Addendum #03

Date: July 14, 2021

Project: Huntington Middle School Modernization and Addition

EXISTING
CONDITIONS
AND DEMO PLAN

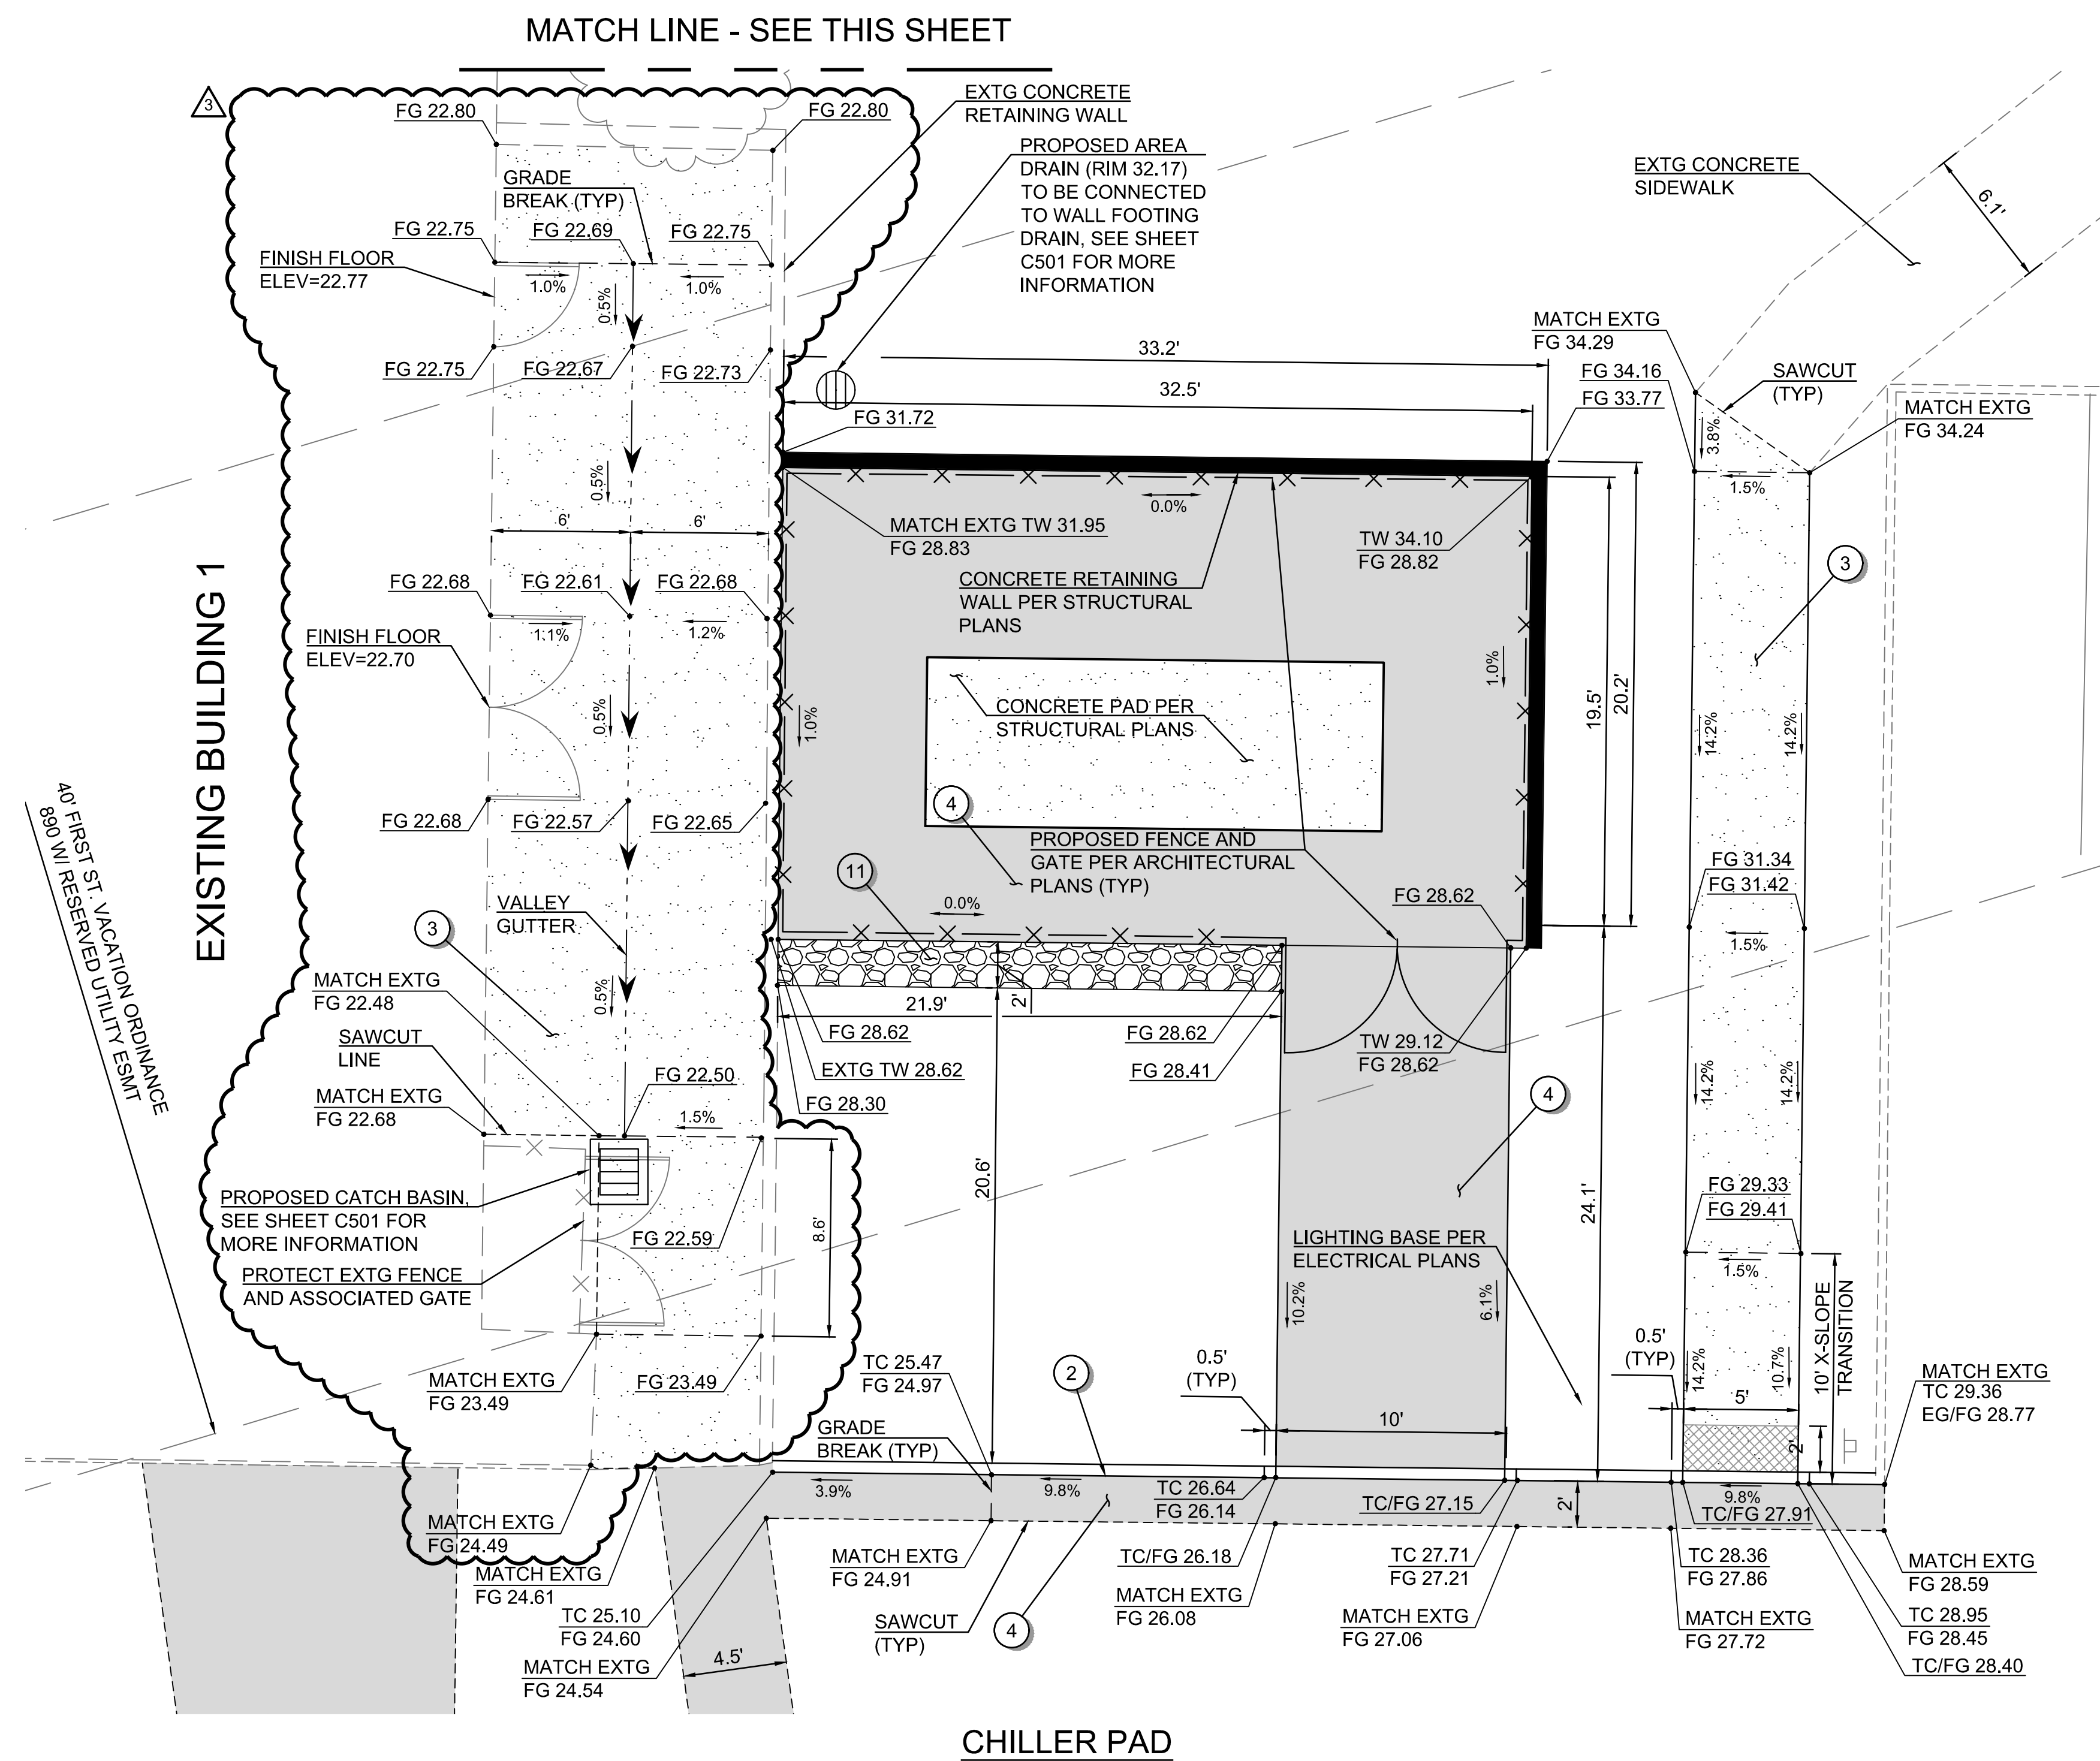
Item #C01 C101 – Existing Conditions and Demo Plan
Add. #03 **Revise** service yard per the attached C101.

CHILLER PAD
GRADING
DETAILS

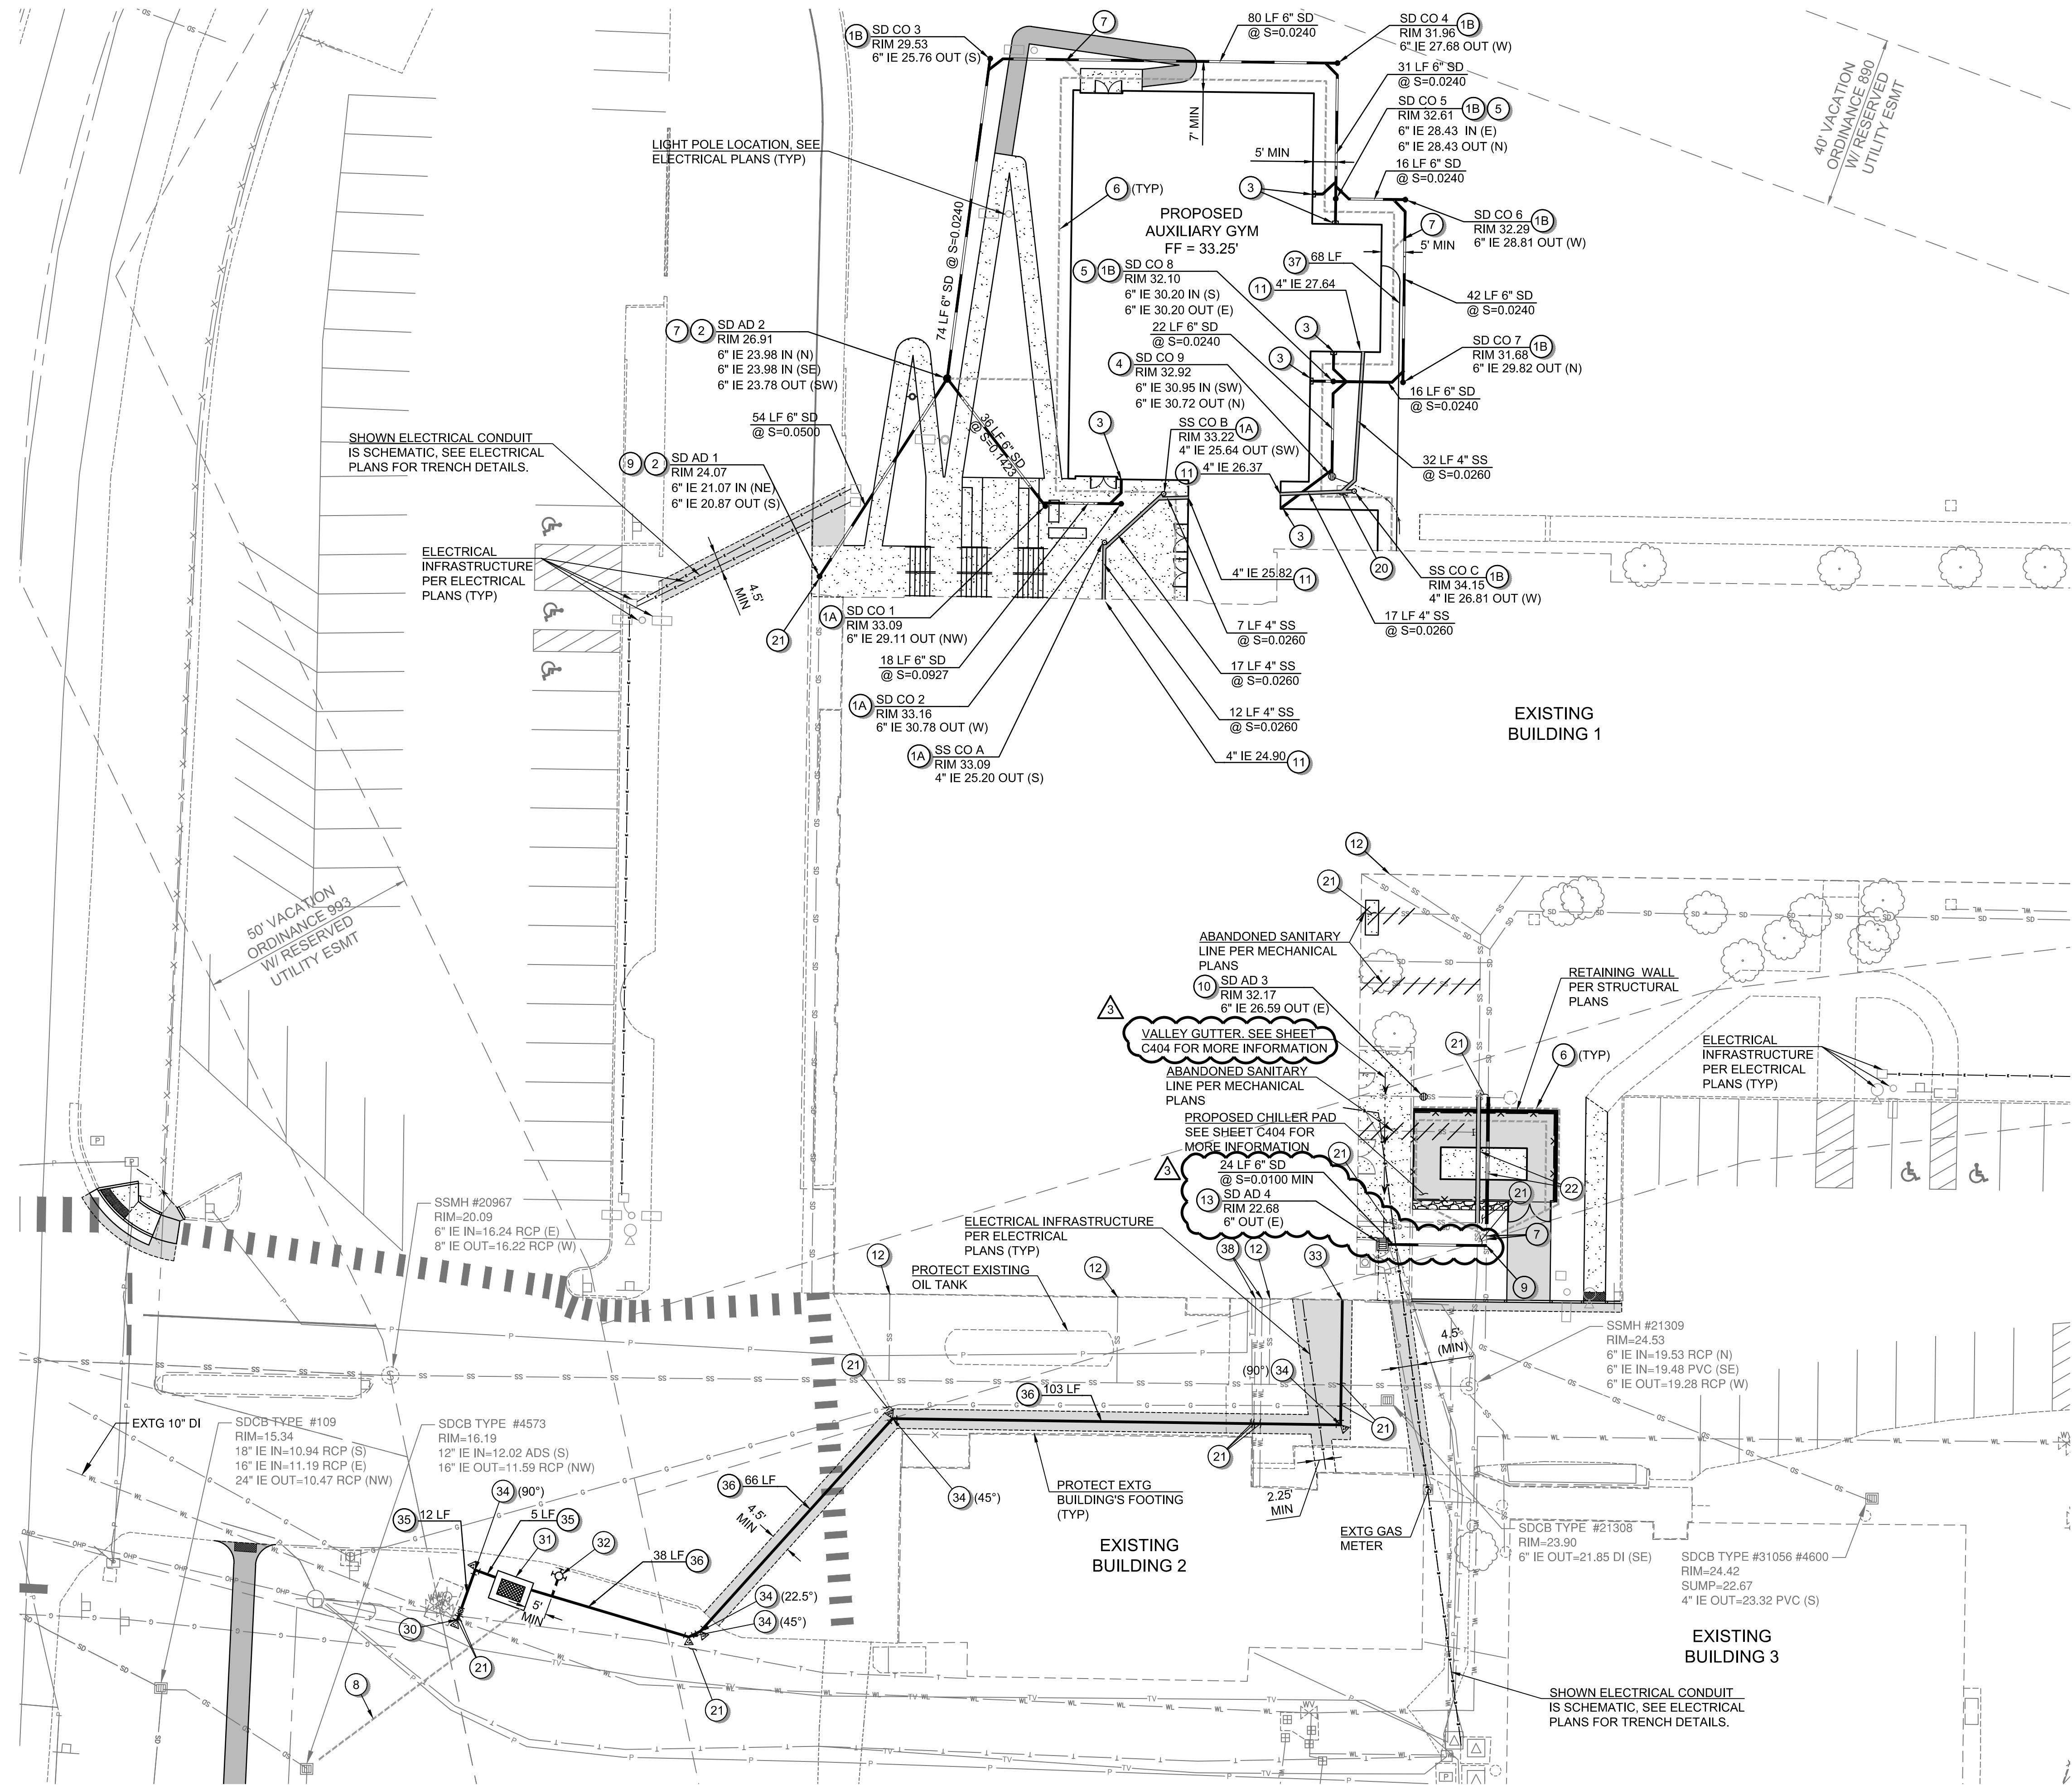
Item #C02 C404 – Chiller Pad Grading Details
Add. #03 **Revise** service yard per the attached C404.

UTILITY PLAN

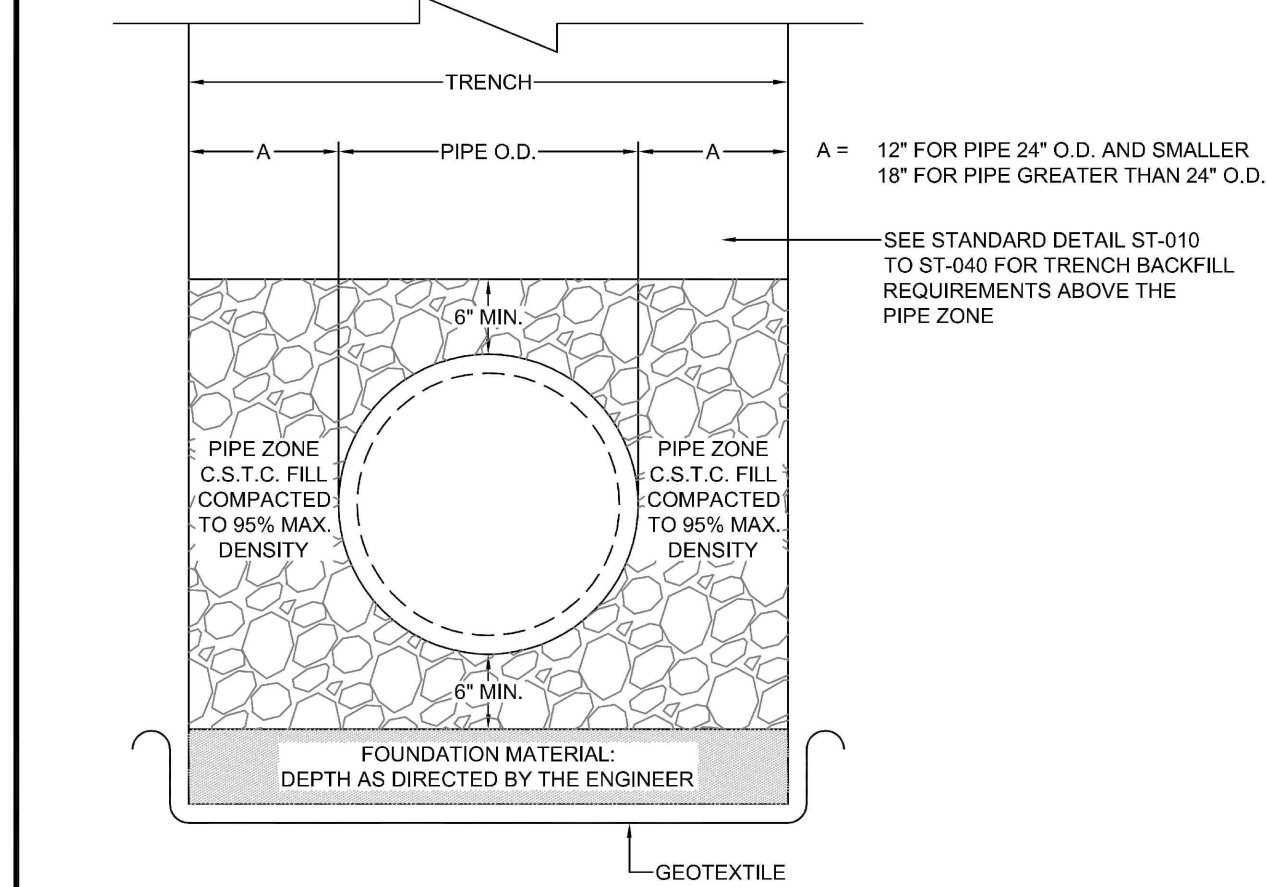
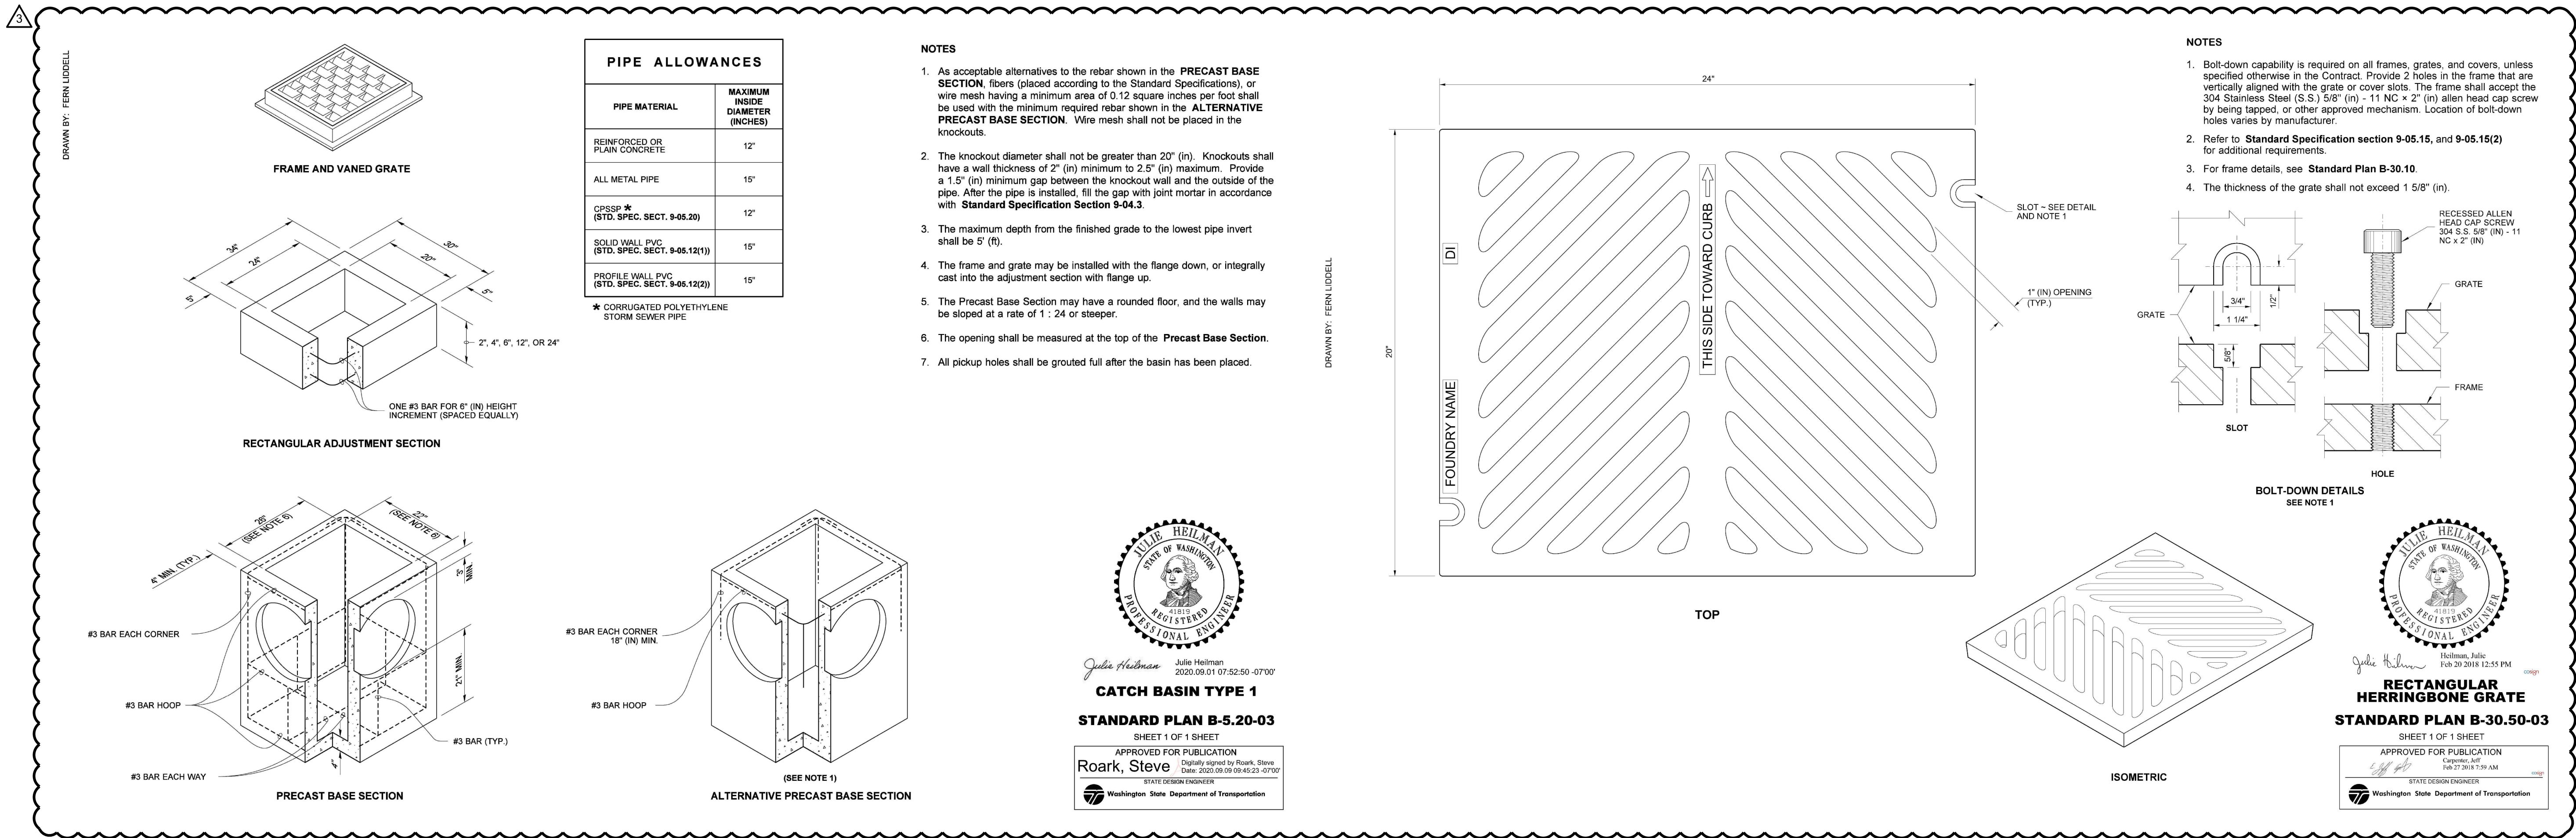
Item #C03 C501 – Utility Plan
Add. #03 **Revise** service yard per the attached C501
